Service Bulletin

Bulletin No. 2015-08
OEM No. 2015-07

MCM 3.0L MPI EC Battery Cable Routing

58773

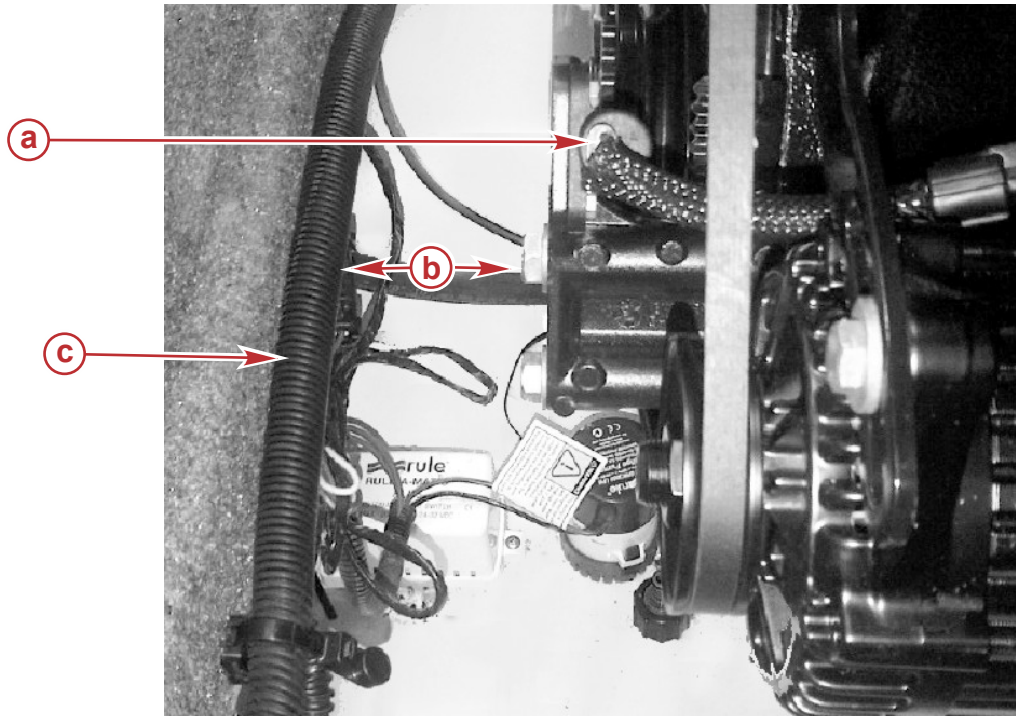
An electromagnetic field is created when current passes through large-gauge current-carrying cables. If these cables are located too near the crankshaft position sensor, they will affect the sensor's signal and adversely affect engine performance. Therefore, engine battery cables and other large-gauge current-carrying cables must not be routed closer than 46 cm (18 in.) to the front of an MCM 3.0L MPI EC engine. Cables mounted closer than this to the crankshaft position sensor will result in engines failing to start, misfiring, or performing poorly.

When diagnosing a running issue on a MerCruiser 3.0L MPI EC engine with one of the symptoms listed above, ensure that both the positive and negative battery cables are at least 46 cm (18 in.) from the crankshaft position sensor or the front of the engine. Also, ensure that the battery ground cable is attached to the rear of the engine on the ground stud. Refer to the installation manual or service manual for identifying the proper location.

Note that attaching a ground cable to the front of the engine will position it closer than the required minimum distance of 46 cm (18 in.) from the crankshaft position sensor, and will result in the engine failing to start, misfiring, and performing poorly.

- a** - Crankshaft position sensor
- b** - Required minimum distance between the front of the engine and the battery cable: 46 cm (18 in.)
- c** - Battery cable

Additionally, the negative and positive battery cables should be routed together (paired) when possible to balance and reduce the disruptive effects of either cable's electromagnetic field.
